**SUBJECT:** Supplemental Information Supporting the License Amendment Request to Remove Technical Specification 3/4.3.2 Table 4.3-2 Note 3 Exemption for Testing Relays K114, K305, and K313  
Waterford Steam Electric Station, Unit 3 (Waterford 3)  
Docket No. 50-382  
License No. NPF-38

**Supplement to Proposed Technical Specification Change**

## **CHANGE 1**

## **CHANGE 2**

#### **Before Sketch (Original Proposed Change)**

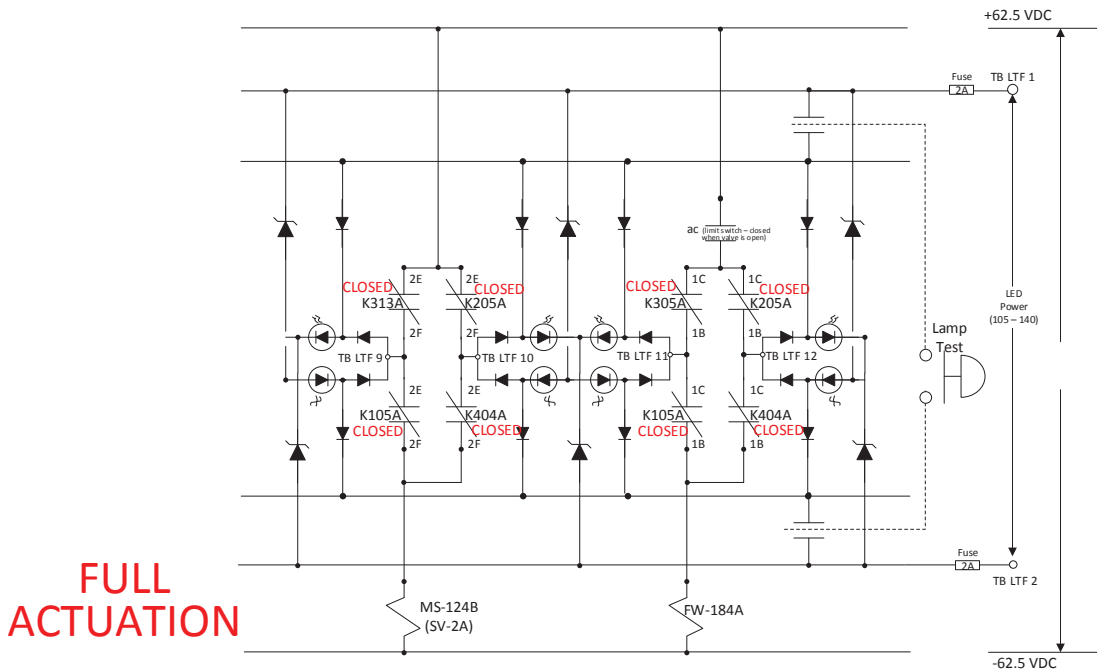
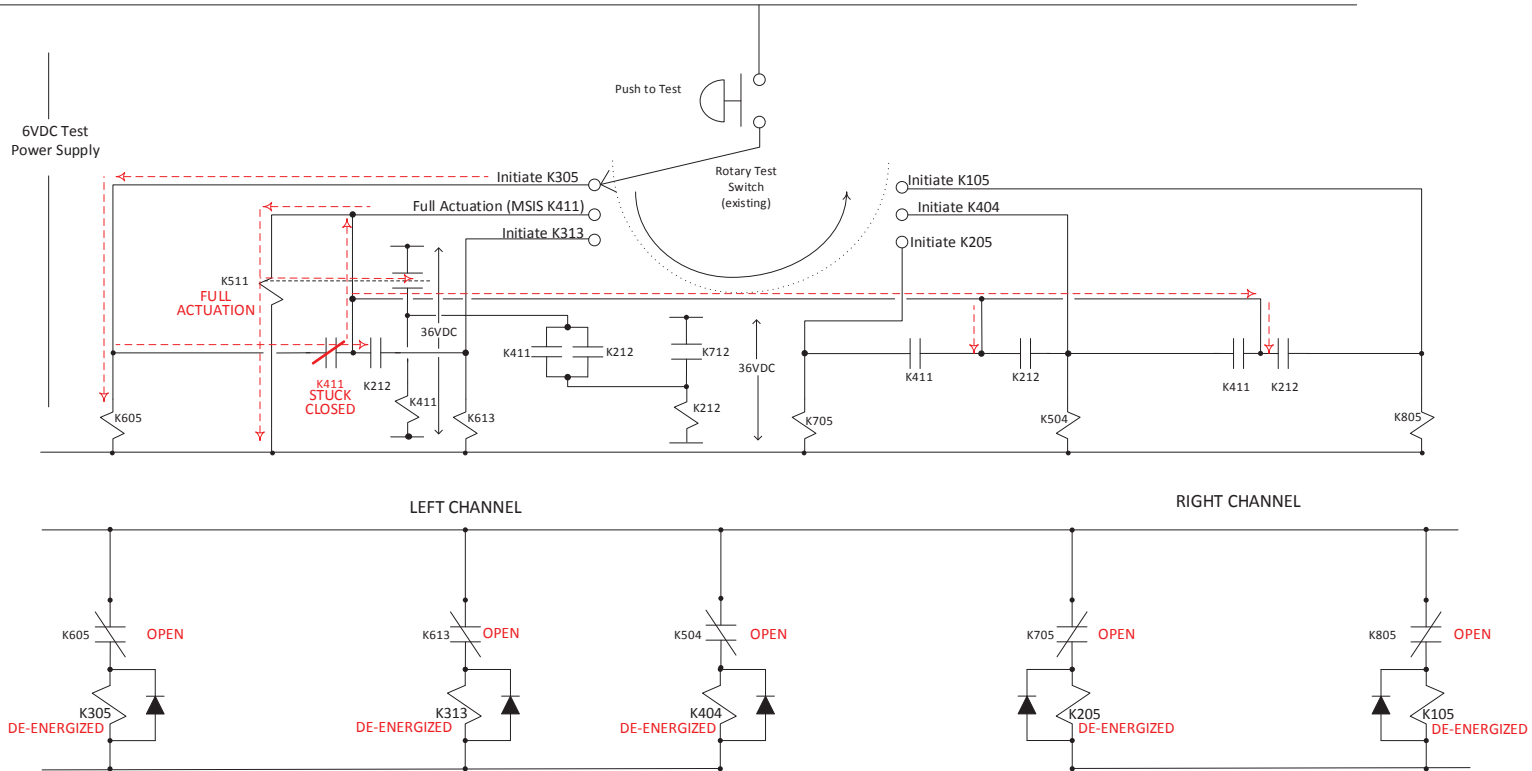
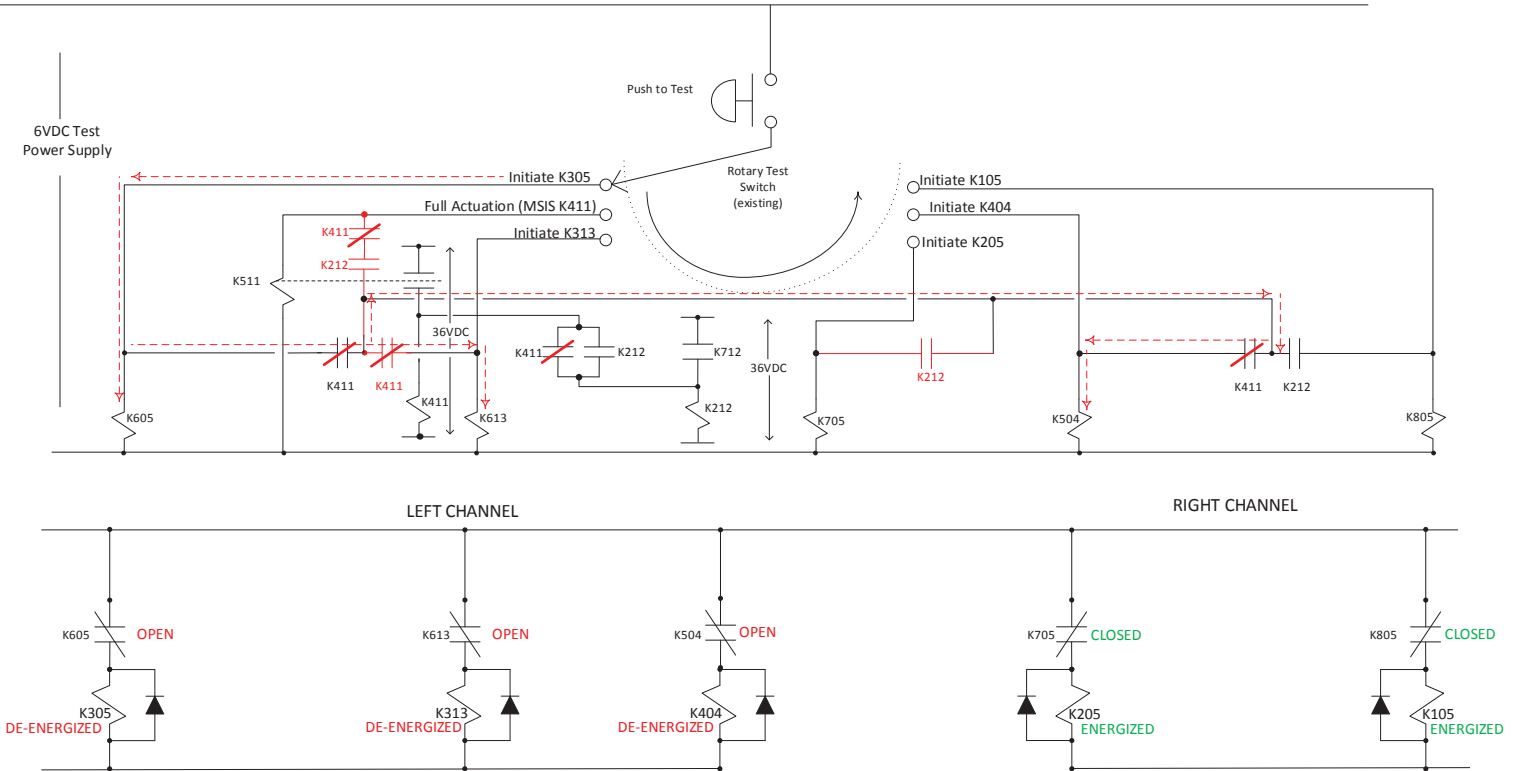
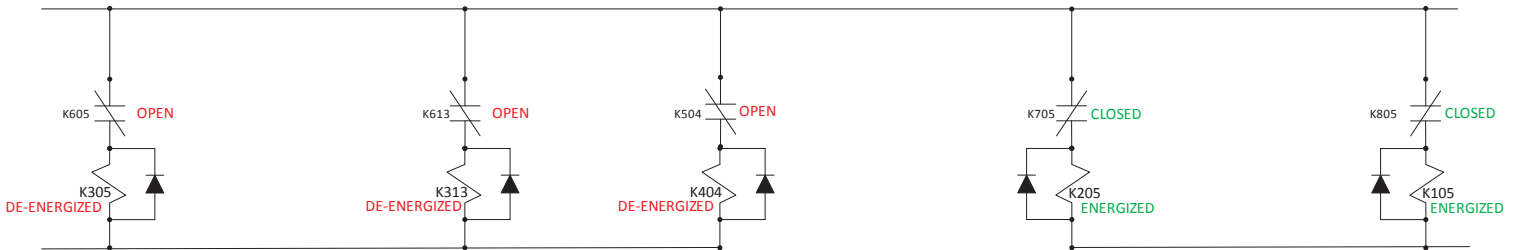
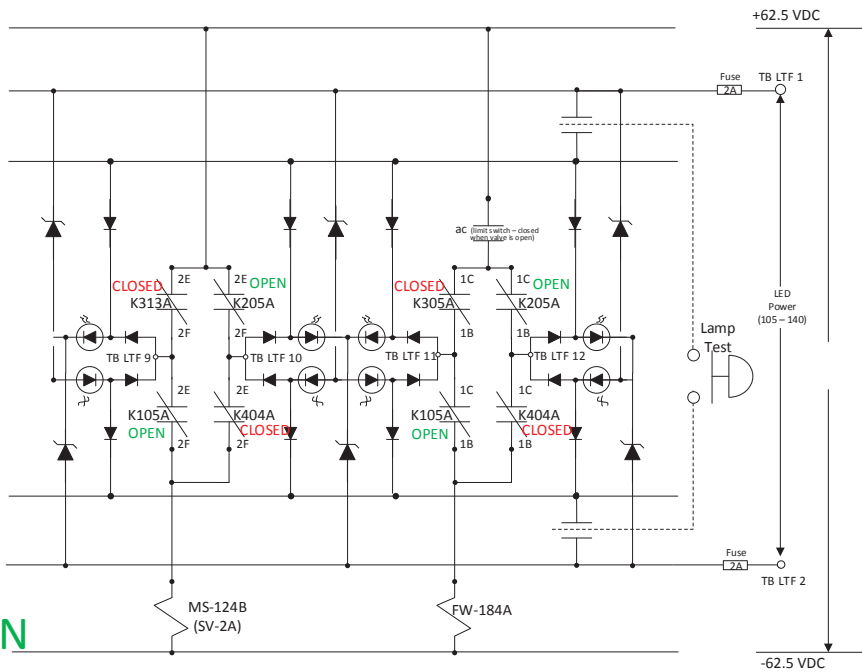
During the Waterford 3 design review of the gang operation test circuit proposed for the ESFAS MSIS and CSAS, it was identified that the potential existed to create test equipment sneak circuits if gang relay (K411 or K212) contact(s) were to become stuck closed. These stuck contact(s) induced sneak circuits that could result in unexpected equipment actuation during online subgroup relay testing. Even though such gang relay contact failures are fully detectable by discrete (offline) subgroup relay testing, it was decided to even further harden the test circuits against the likelihood of these detectable gang relay contact failures.

The before sketch (see Enclosure page 3) depicts the scenario of a single K411 contact stuck closed (single K212 is similar) after performing gang operation achieving full actuation of the downstream SOV during a plant outage. In this scenario, the plant is in Mode 1 (Power Operation), the contact [unknowingly] remains stuck closed, and the discrete subgroup relay test is being performed. The rotary test switch is aligned to initiate K305 for discrete subgroup relay testing. When the INITIATE ACTION pushbutton is depressed, a full actuation would occur due to the stuck closed K411 contact. The dashed red arrows of the sketch shows the voltage path through the stuck K411 contact that ultimately energizes the gang operation test relay K511. The energizing of K511 triggers a full actuation. A single stuck contact or an entire stuck gang relay (K411 or K212) would have the same result in this circuit.

The after sketch (see Enclosure page 4) depicts the design which has been “hardened” against the voltage sneak paths described in the previous scenario. The addition of the K411 and K212 contacts block the voltage from the K511 coil during discrete subgroup relay testing, thus preventing full actuation of MSIS or CSAS under the condition of a single stuck gang relay contact (K411 or K212) scenario. The ESFAS MSIS and CSAS test circuits are also hardened for channel protection such that a stuck gang relay (all contacts for K411 or K212 closed) would not result in full actuation of MSIS or CSAS. The “left channel” is arranged with K411 contacts and the “right channel” is arranged with K212 contacts. In the scenario depicted, if all gang relay K411 contacts are stuck closed, a full actuation would not occur. The only result would be left channel subgroup relays actuate (K212 results are similar for right channel only). Full actuation requires both left and right channel subgroup relays to achieve full actuation. For the condition described, all left or right channel relays actuated would be detected by Light Emitting Diode (LED) Test Fixture indication. Under the described scenario, two LED lights will illuminate. If the circuit were operating properly and there are no stuck gang operated test relay contacts, only a single LED out of 4 per group for a given valve would illuminate.

#### After Sketch (Final Design)

In the License Amendment Request, the following paragraph was provided on Page 7 of 20 of Attachment 1 of Reference 2:

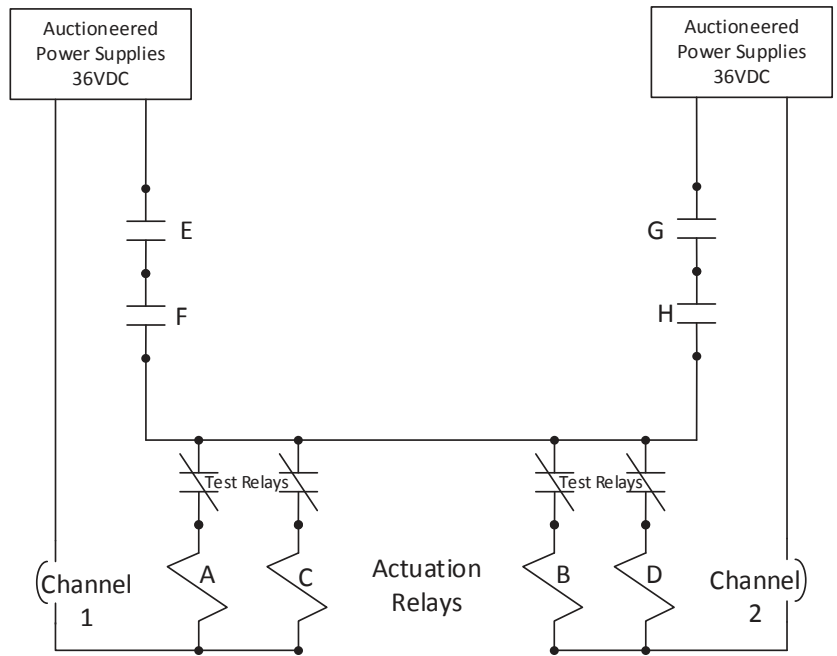
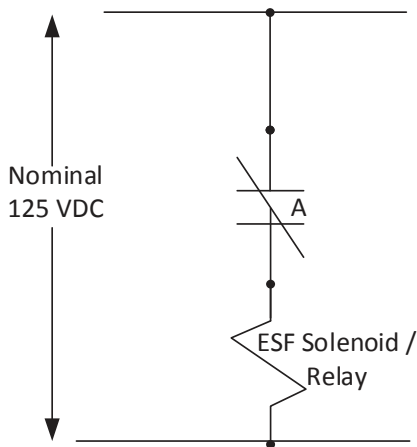
Errors were identified during the design development and design verification for the modification that required revision to design documents and the 10 CFR 50.59 evaluation. The 10 CFR 50.59 evaluation and the design documents were revised accordingly. A portion of the license amendment request which describes the ESFAS modification and some of the schematics provided were based on these documents. The necessary change to the information in the license amendment request is provided below. The changes do not affect the proposed amendment to the Technical Specification provided in the license amendment request.

Assume relay A is the original relay. In series with the "A" contact is a newly installed "B" contact. If a short circuit would occur across the relay A coil, this would not cause an actuation to occur due to relay B having a separate negative and circuit breaker. The "A" contact would close while the "B" contact would remain open thus preventing the energization of the downstream ESF solenoid / relay. By paralleling 2 out of 2 with a second 2 out of 2, the actuation system can achieve a better result. The change in logic to address probability of failure to actuate (fail "on") is evaluated as equal to or better than that of the existing single subgroup relay. The existing configuration requires only one actuation relay per train to respond to its respective ESF actuation signal. The one actuation relay is actuated by one specific trip leg (valve group, refer to UFSAR figures 7.2-17 and 7.3-5). Failure of the valve group specific trip leg would result in failure of the actuation relay to respond. The proposed activity adds permissive relays to both the primary's trip leg and the other trip leg using both available trip paths (valve group / pump group). The resulting configuration requires successful actuation of both valve group and pump group trip paths and subsequent actuation of both primary and permissive or permissive and permissive subgroup relays. However, based on UFSAR Table 7.2-5 and sections 7.3.1.1.1.3, 7.3.1.1.2.2.3, 7.3.1.1.3.3, and 7.3.1.1.4.3, successful actuation of the Safety Injection System (SIS), Recirculation Actuation Signal (RAS), CSS (with exception of the valves addressed in this evaluation), and the Containment Isolation System (CIS), respectively, require a similar scheme. The successful actuation of BOTH valve group and pump group trip paths and their associated subgroup relays is required for successful system actuation. In that regard, this modification does not increase the probability of actuation failure of affected MSIS or CSS components any more than the probability of actuation failure of SIS, RAS, CSS, or CIS components as already described in the UFSAR and improves the probability by adding two subgroup paths: path 1 being A and B or path 2 being C and D, with either path providing successful actuation of downstream actuated device (valve).

Assume relay A is the original relay. In series with the "A" contact is a newly installed "B" contact. If a short circuit would occur across the relay A coil, this would not cause an actuation to occur due to relay B having a separate negative and circuit breaker. The "A" contact would close while the "B" contact would remain open thus preventing the energization of the downstream ESF solenoid/relay. By paralleling 2 out of 2 with a second 2 out of 2, the actuation system can achieve a better result. The change in logic to address failure to actuate (fail "on") is evaluated as equal to or better than that of the existing single subgroup relay. The existing configuration requires only one actuation relay per train to respond to its respective ESF actuation signal. The one actuation relay is actuated by both ESF trip legs (pump and valve groups, refer to UFSAR figures 7.2-17 and 7.3-5). Failure of the pump or valve group specific trip leg would result in failure of the actuation relay to respond. The proposed activity adds permissive relays to both trip legs of available trip paths (pump group / valve group). The resulting configuration maintains the requirement for successful actuation of both valve group and pump group trip paths and subsequent actuation of one of two sets of subgroup relays. All ESFAS functions require a similar scheme: the successful actuation of BOTH valve group and pump group trip paths and their associated subgroup relays for successful system actuation. There is no change to the failure modes as described in UFSAR 7.2-5.

From W3F1-2017-0067, Attachment 1, Page 6 of 20:

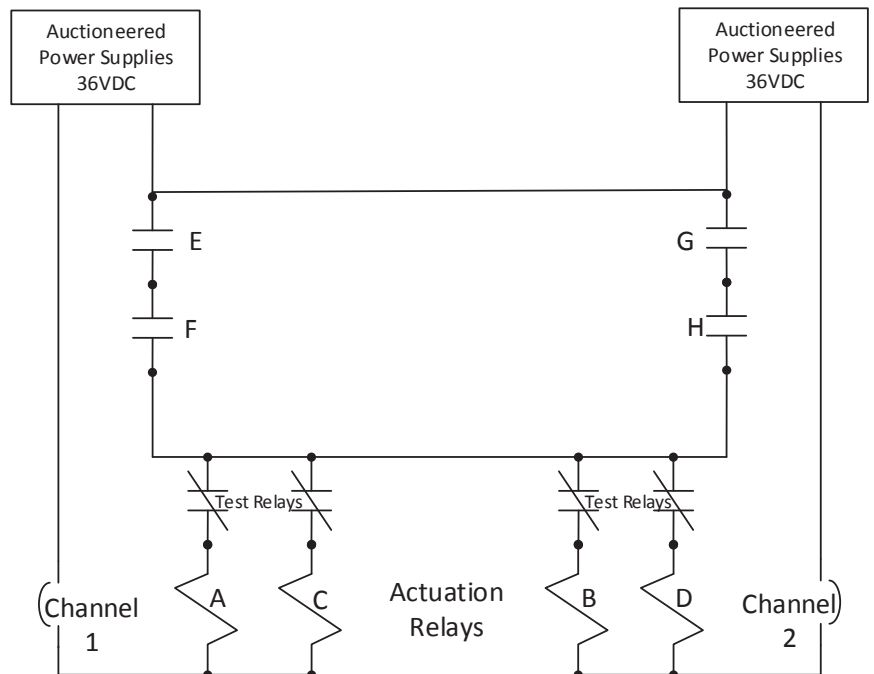
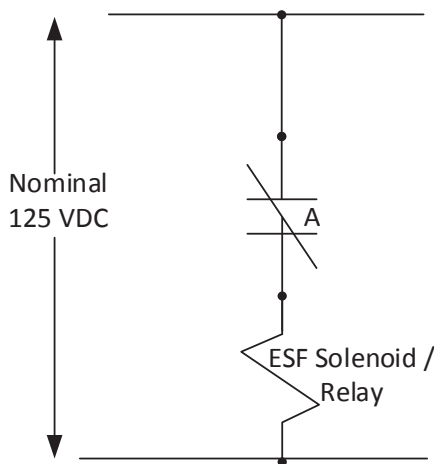
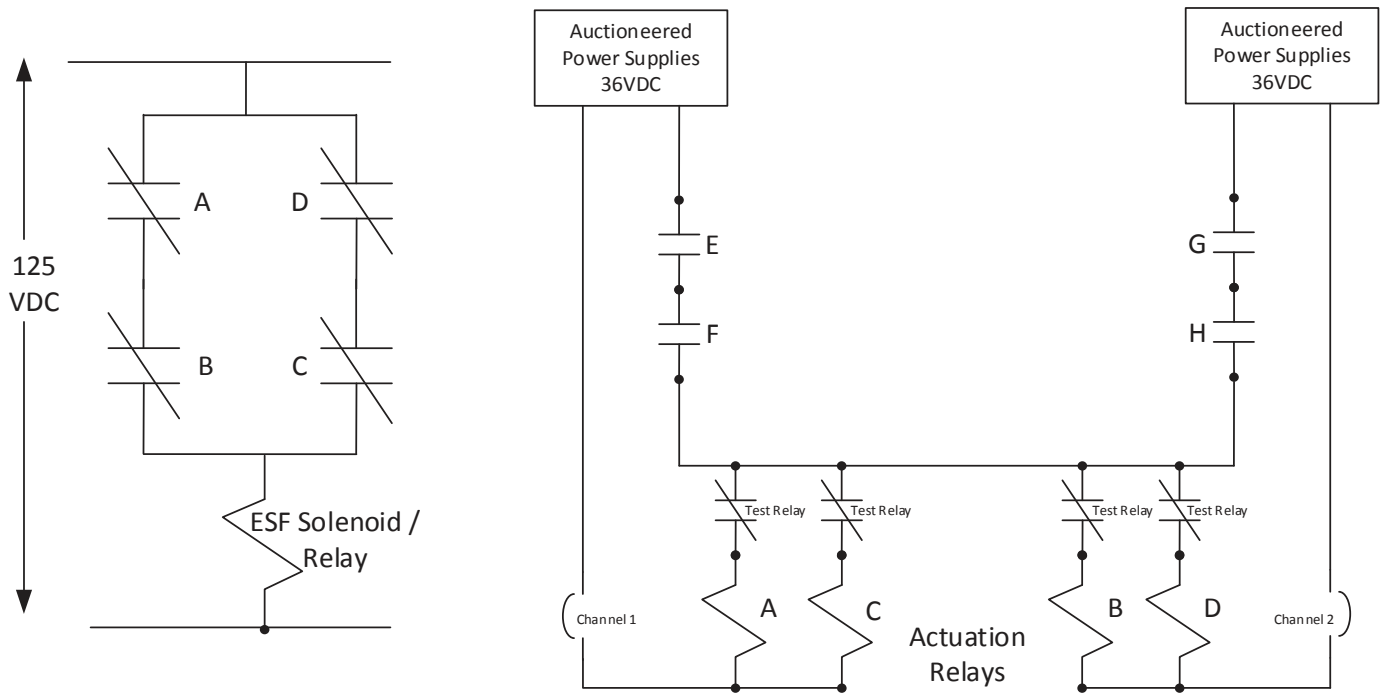
On the following pages, the simplified schematic that was included in the license amendment request is provided; following each is the revised schematic (showing the cross tie) which replaces it.

Replace with:
